Revised Structure Type Study

Ramp C over Fairground Road

SCI-823-0.00
PID No. 19415

Prepared for
Ohio Department of Transportation

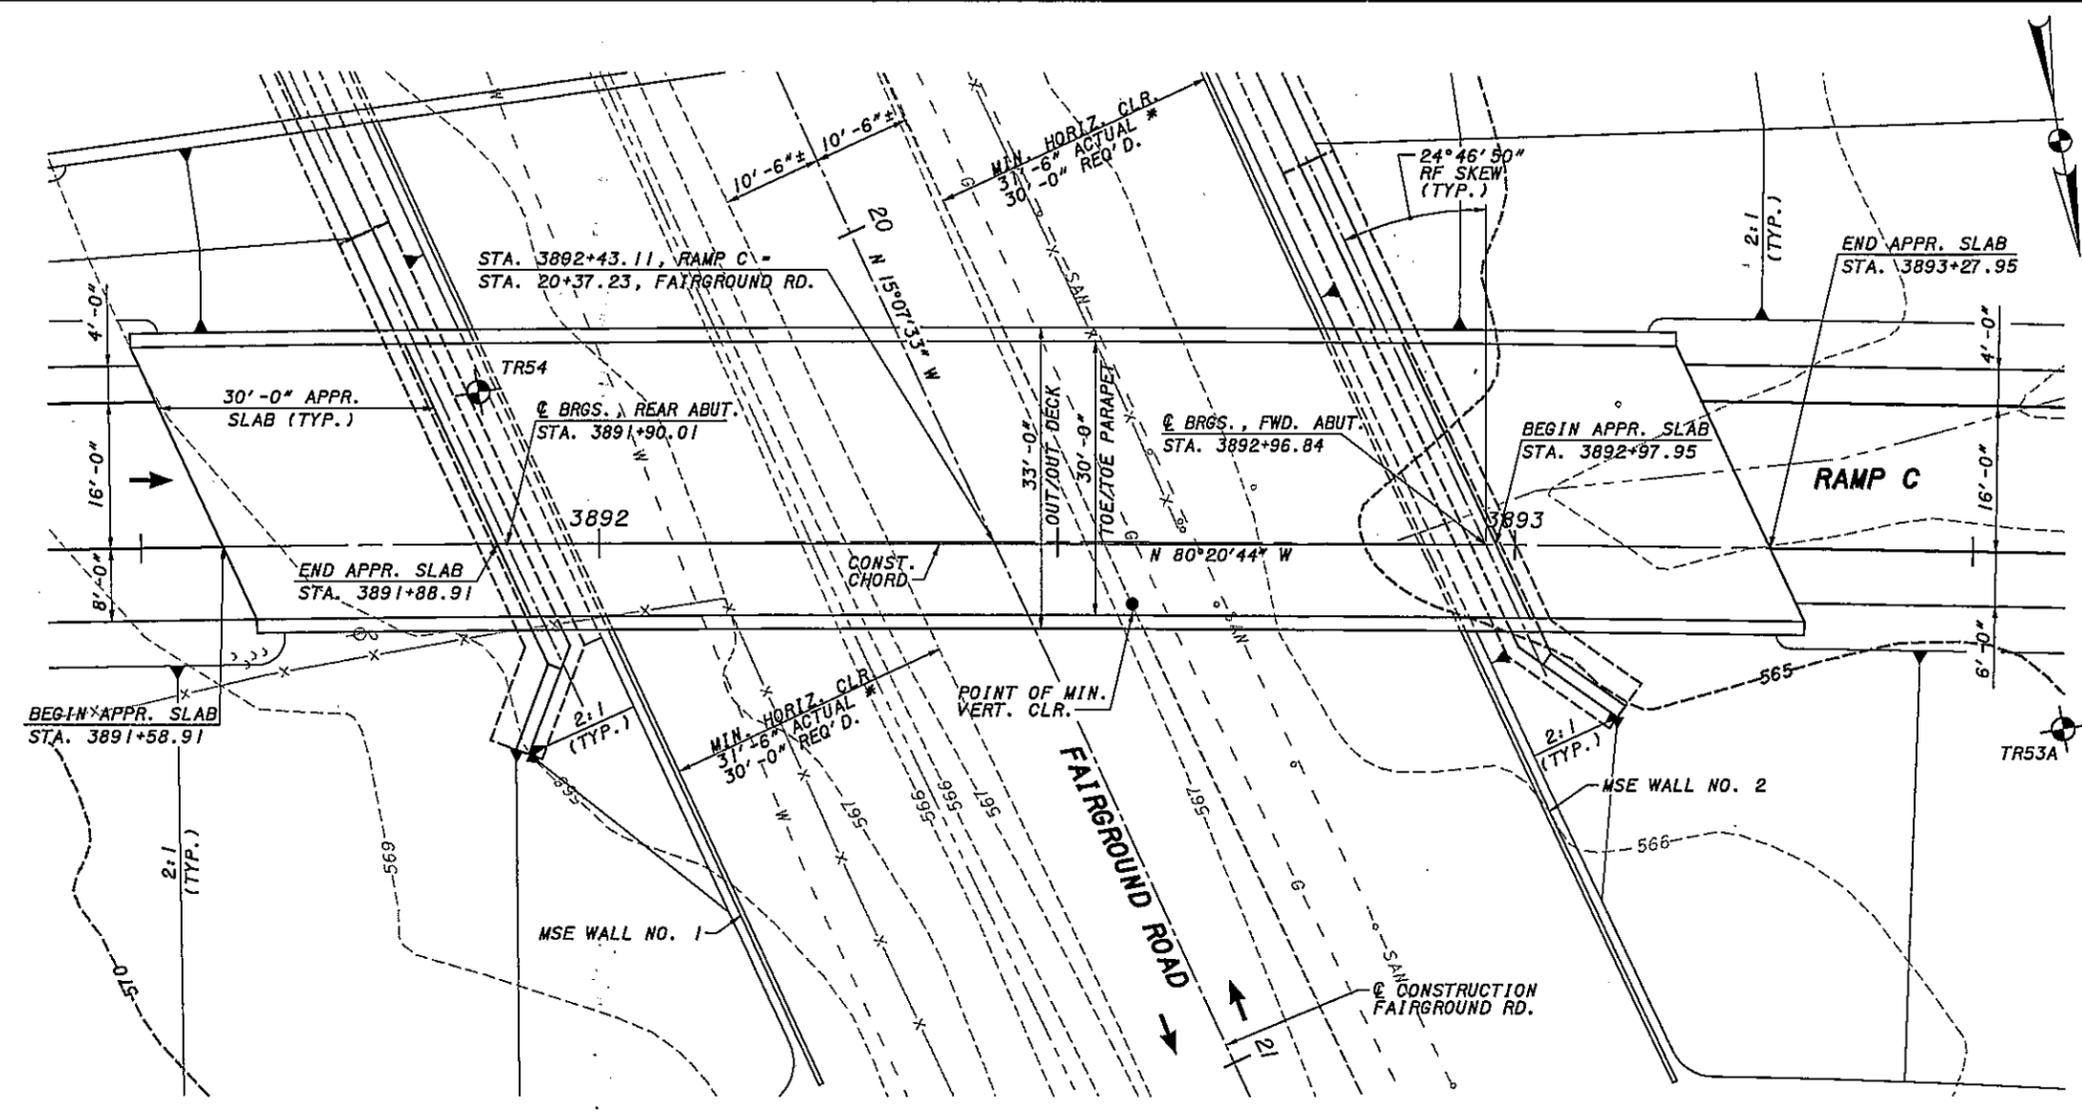
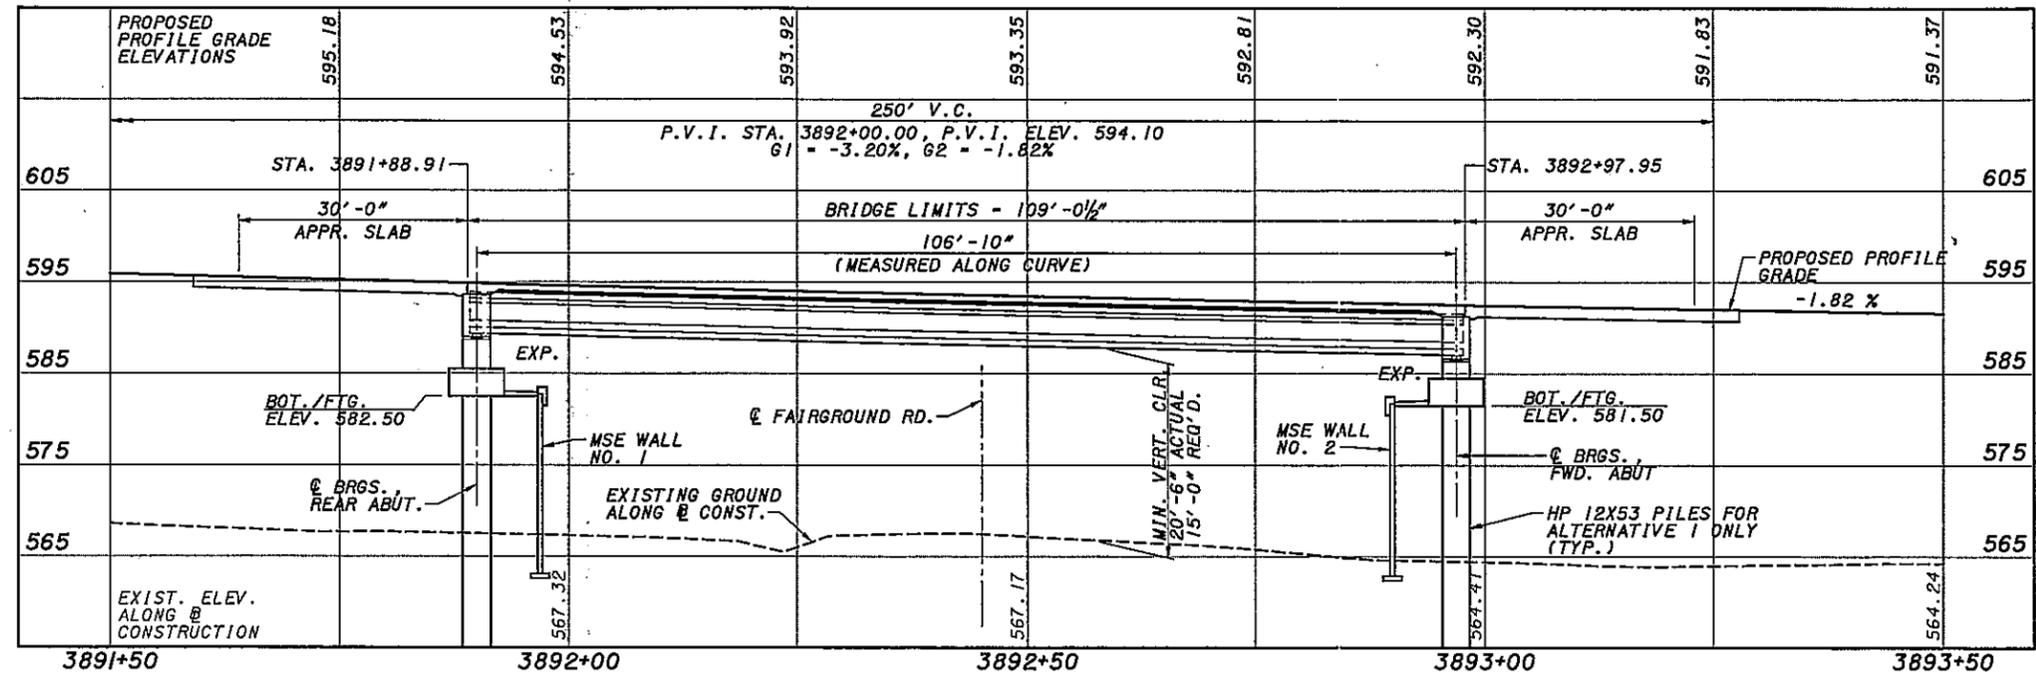
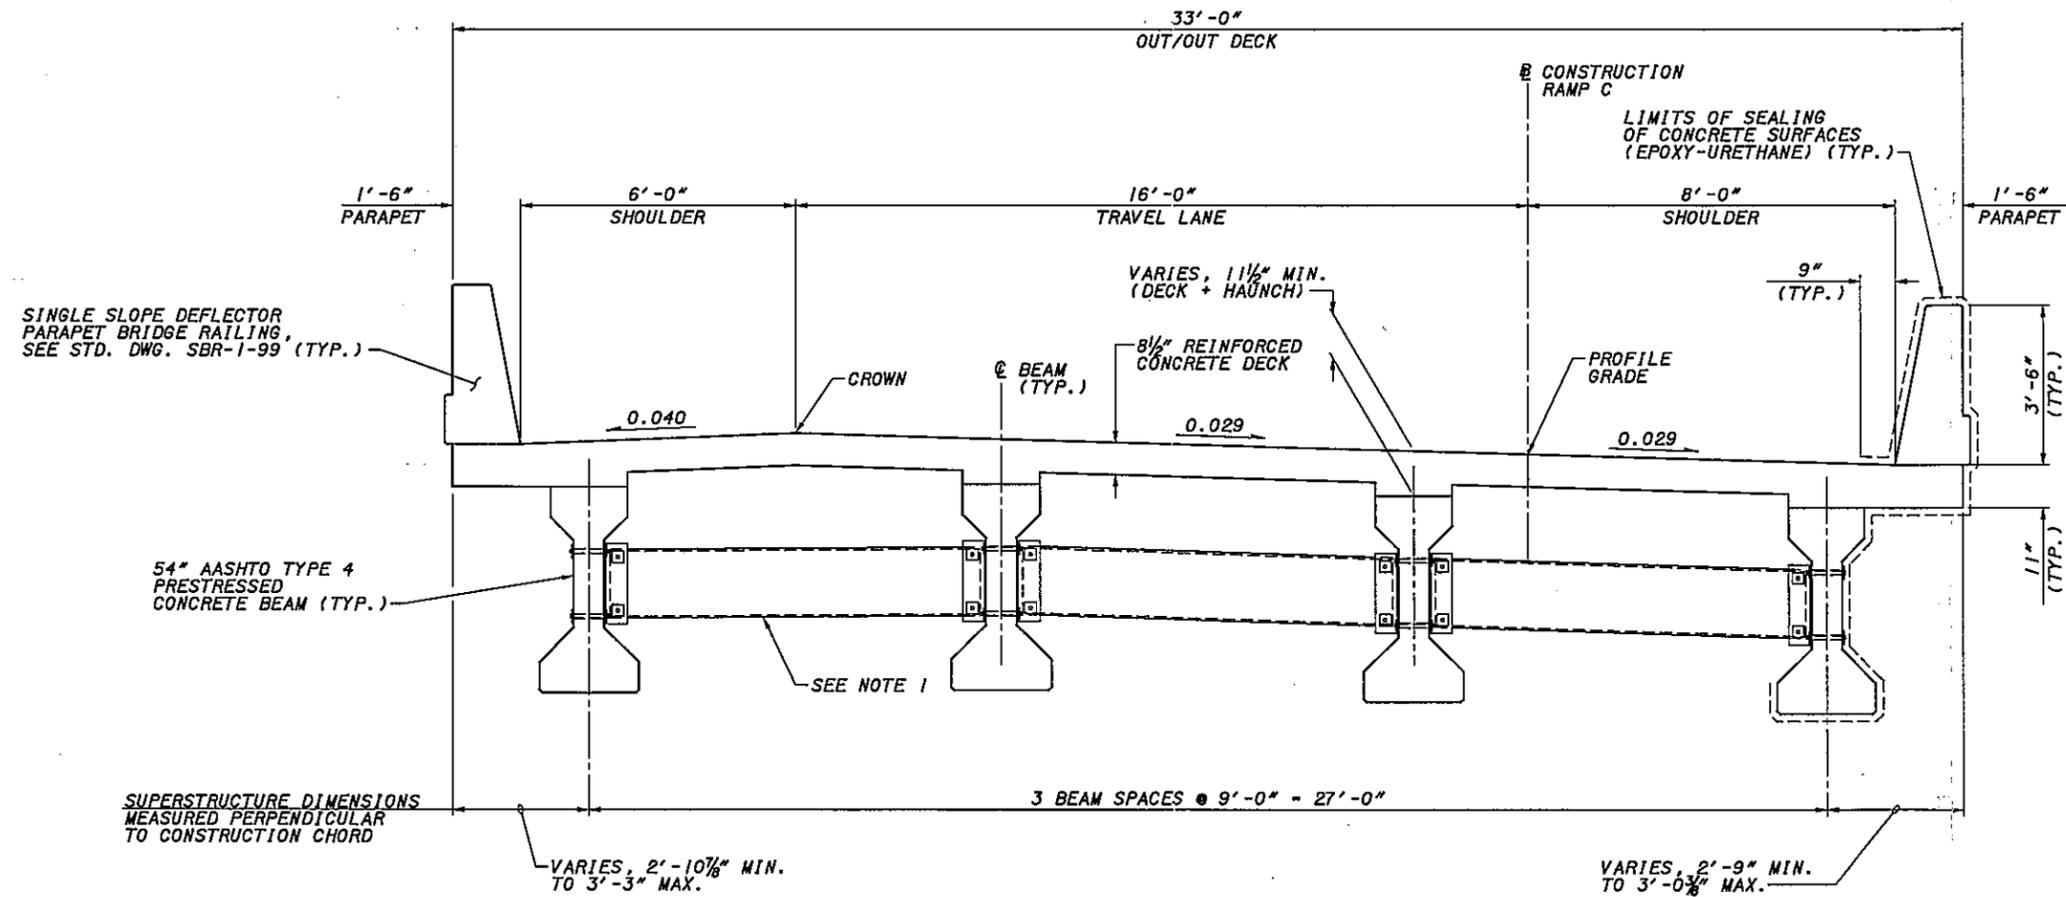
3. Soil boring TR53A seems to be missing. Please include all the soil borings in the next submittal.
4. The profile grade for the entire project needs to be reevaluated one more time in order to minimize the difference between the amounts of cut and fill. We feel that the 22'-2" proposed vertical clearance shown on the Site Plan can be further reduced. Please verify the minimum required vertical clearance for the proposed structure. Refer to L&D Manual, Volume 1, Fig. 302-1E.

5. We could not verify the 10'-0" minimum required horizontal clearance. Please refer to L&D Manual, Volume 1, Fig. 600-1.

6. The existing lane widths for Fairground Road are shown as 2-lanes @ 10'-6" per lane. Fairground Road might experience an increase in traffic at some point in time upon completion of this project. Is there a plan for future widening for Fairground Road or was this even considered? This will affect the proposed bridge limit.

7. Limits for Southwest and Southeast wingwalls are not clearly shown in the plan view. Also, please investigate if the 45-degree wingwalls can be utilized at SW and SE wingwalls.

Site Plan (1/3)	3. Soil boring TR53A seems to be missing. Please include all the soil borings in the next submittal.	Will comply.
Site Plan (1/3)	4. The profile grade for the entire project needs to be reevaluated one more time in order to minimize the difference between the amounts of cut and fill. We feel that the 22'-2" proposed vertical clearance shown on the Site Plan can be further reduced. Please verify the minimum required vertical clearance for the proposed structure. Refer to L&D Manual, Volume 1, Fig. 302-1E.	Will comply. Per the L&D Manual, the preferred vertical clearance for Fairgrounds Road is 15'-0". In this re-submittal package, we are proposing a structure with minimum vertical clearance of 20'-6". The profile grade is being driven by the Ramp C over Norfolk Southern bridge to the west, specifically with the addition of two new rail lines per District direction in March 2006. The re-submittal of the Ramp C over Norfolk Southern bridge will be provided at a later date.

Site Plan (1/3)	5. We could not verify the 10'-0" minimum required horizontal clearance. Please refer to the L&D Manual, Volume 1, Fig. 600-1.	Will comply. The minimum required for an MSE outside the clear zone is 30'-0"; the span has been adjusted to meet this minimum horizontal clearance.
Site Plan (1/3)	6. The existing land widths for Fairground Road are shown as 2-lanes @ 10'-6" per lane. Fairground Road might experience an increase in traffic at some point in time upon completion of this project. Is there a plan for future widening for Fairground Road or was this even considered? This will affect the proposed bridge limit.	The District spoke to the Scioto County Engineer regarding this. Per communication dated September 1, 2005, there are no plans to widen Fairgrounds Road in the future, but allow for 24' pavement.
Site Plan (1/3)	7. Limits for the Southwest and Southeast wingwalls are not clearly shown in the plan view. Also, please investigate if the 45-degree wingwalls can be utilized at SW and SE wingwalls.	Will comply. However, from an aesthetic viewpoint, having the Southwest and Southeast wingwalls of this bridge mate with the Northwest and Northeast wingwalls of the SR 823 over Fairgrounds Road bridge would be visually superior.
